Engineering Design Services For Aerospace Parkway Widening (4AERO2)

Amendment: Contract No. CT-PW-17-337, Amendment No. Two (2). This amendment increases the contract amount by \$79,475.16.

<table><tr> <td align="center" colspan="2"><b>CONTRACT</b></td> </tr><tr> <td><b>AMENDMENT NO.</b></td> <td><u>02</u></td> </tr></table>

**RE: 4AERO2 Aerospace Parkway Phase2 – Change Order Request No. 2**

Figure 1

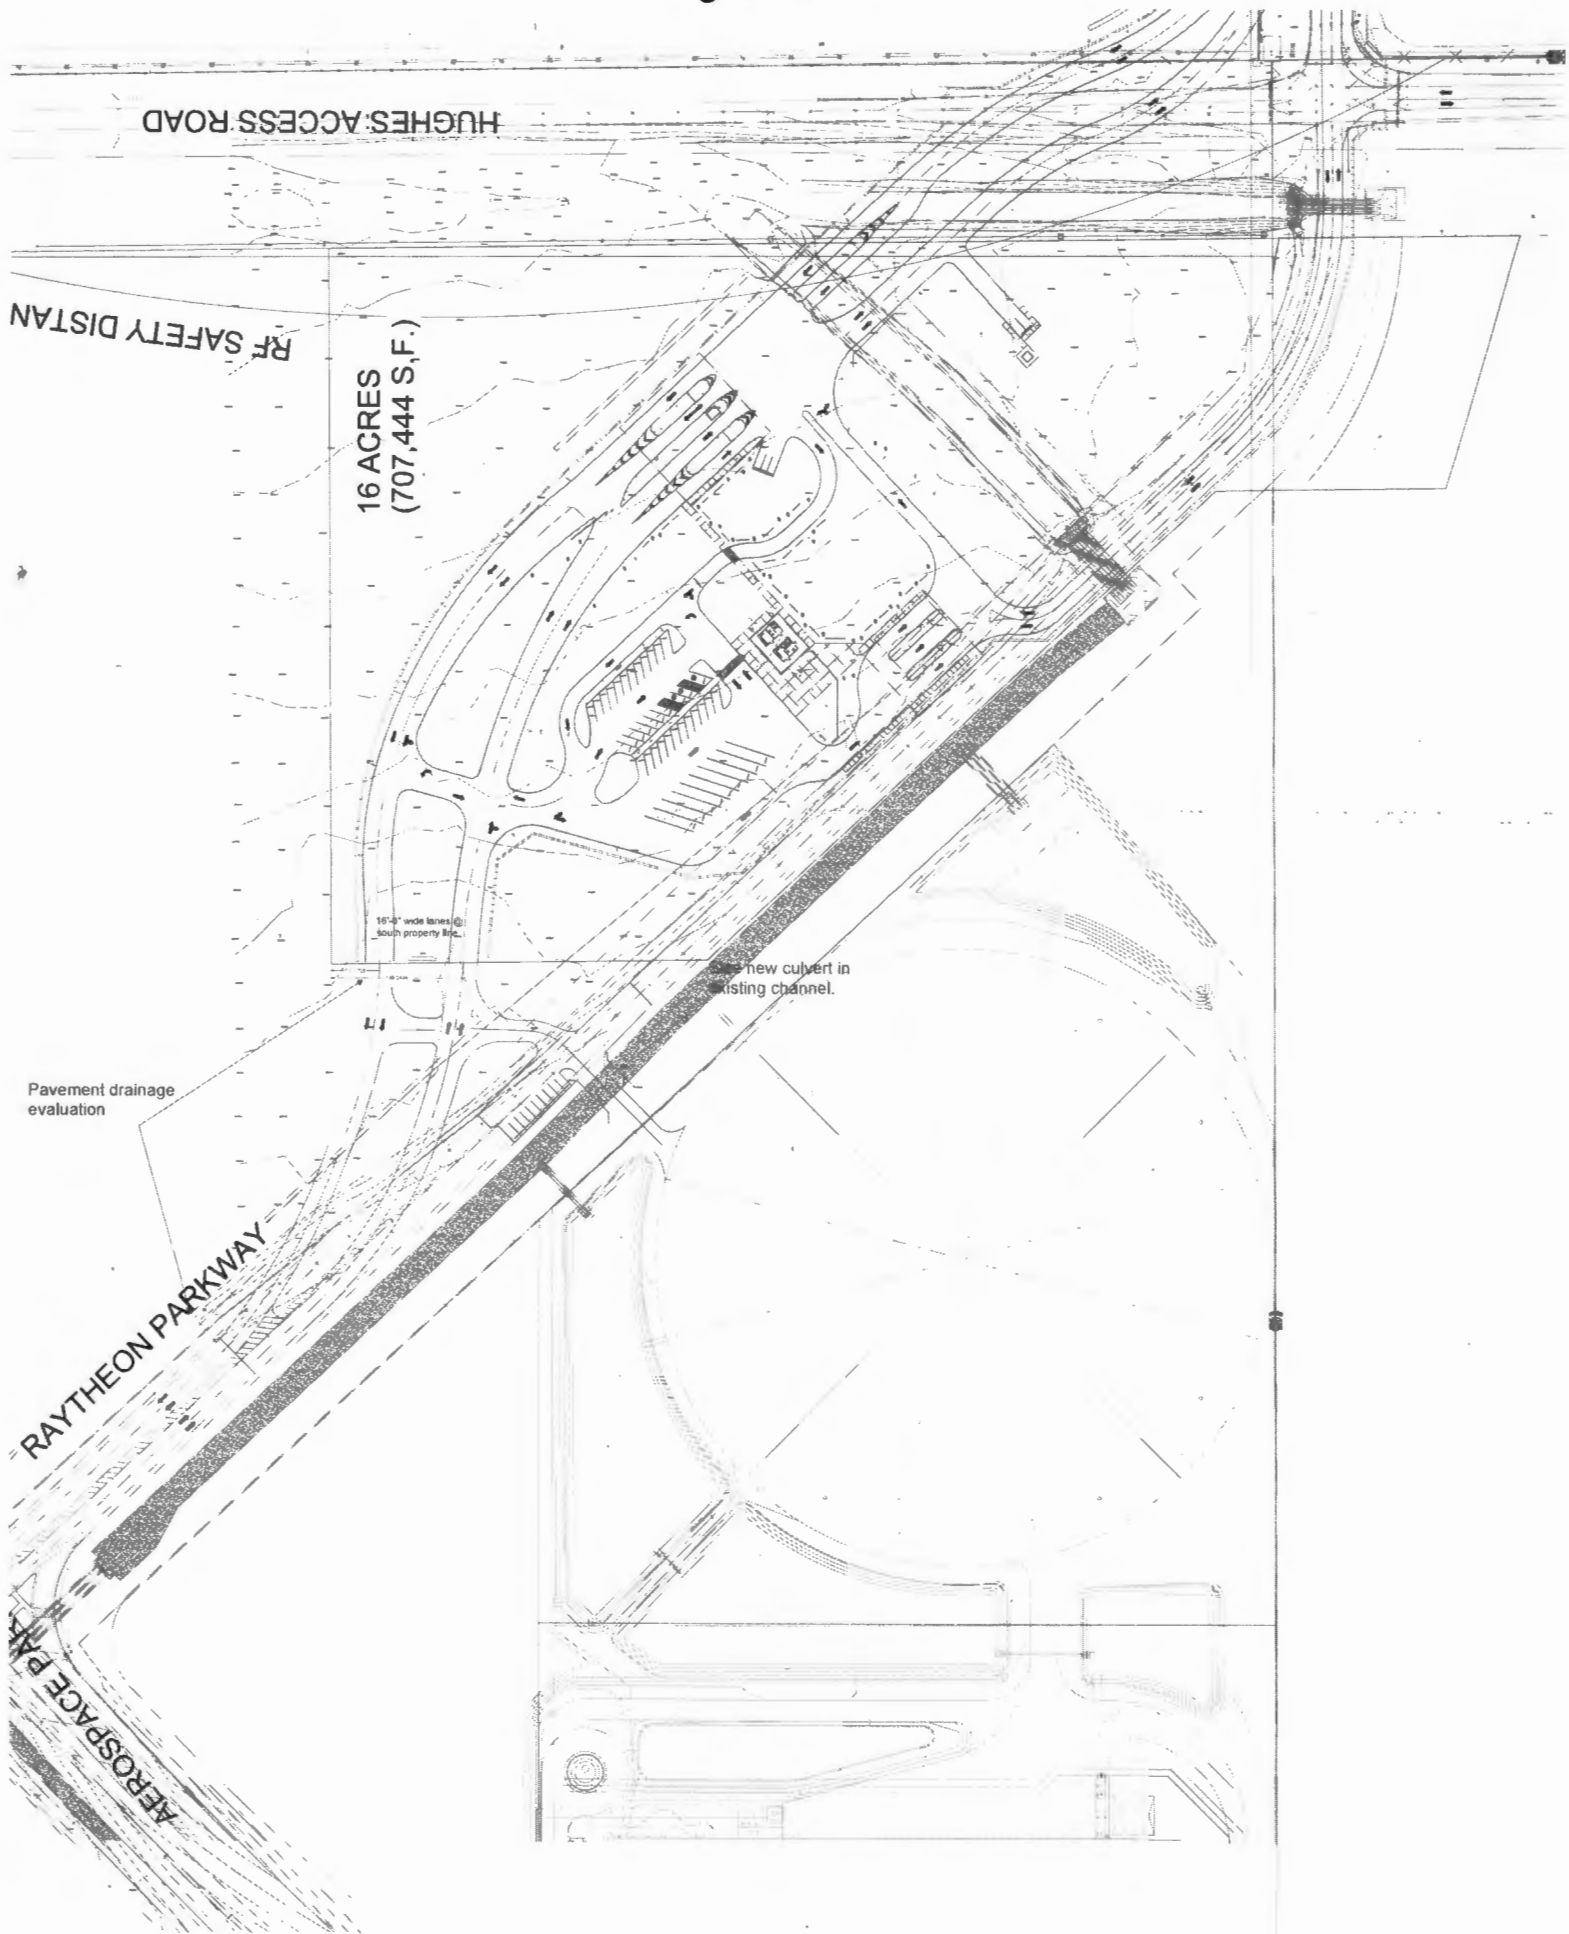
The scope of work for this effort includes CMG Drainage Engineering, Inc. (CMG) providing additional services per the meeting discussion on Friday September 22, 2017 and also the attached exhibit (Figure 1) which delineates the Raytheon Parkway realignment. The purpose of which would be to encapsulate in individual memos: 1) the different scenarios of development and the means to phase detention improvements and incorporate them into the basin being designed and constructed by Aerospace Parkway Phase 2; 2) the drainage analysis for the Raytheon Parkway Realignment.

**Task 3.2 Raytheon Pkwy Realignment Drainage Memorandum** CMG will prepare a memo to document the analysis and methodology to support the realignment design of Raytheon Pkwy as shown on Figure 1. The analysis will require proposed culvert analysis using HEC-RAS and pavement drainage calculations to ensure the public roadway meets Pima County Department of Transportation pavement drainage requirements.
